Item 12.**Development Application: 206-208 King Street, Newtown**

File No.: D/2017/1700

Summary

Figure 17: The roof plan showing the additional floor area

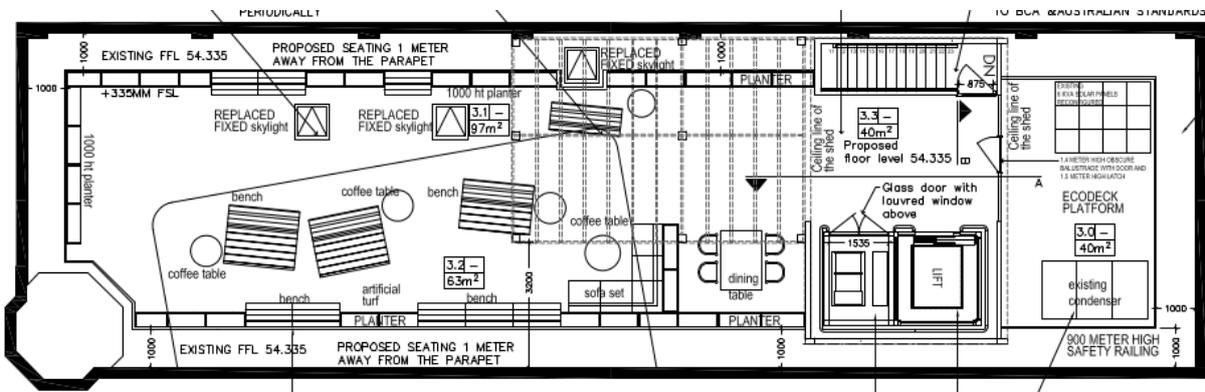
49. A rooftop communal area is proposed as part of the boarding house development. In order to provide equitable access to this space, lift access is required. It is the provision of this enlarged structure, including the lift and stair access, which results in an increased non-compliance with the height development standard as prescribed by the LEP. See Figures 17 and 18 below.

Figure 18: The Brown Street elevation showing the 15m height limit

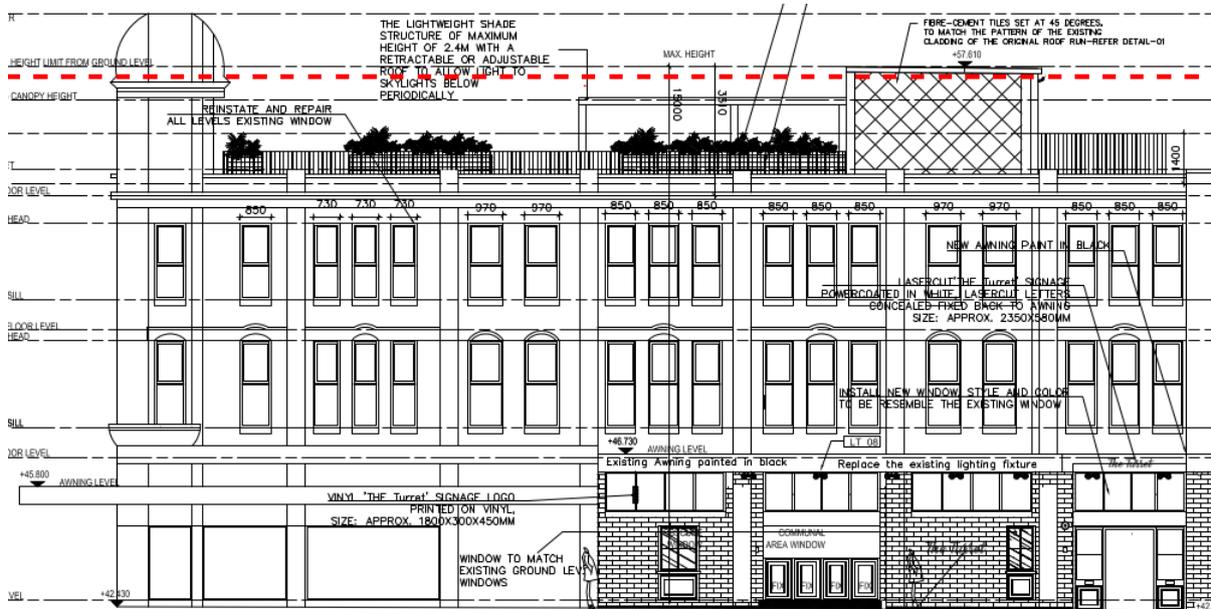
46. The existing turret at the front of the building exceeds the building height development standard however the existing roof addition complies with the maximum height control as prescribed by the LEP. The proposed roof addition will result in a minor non-compliance with the building height development standard.
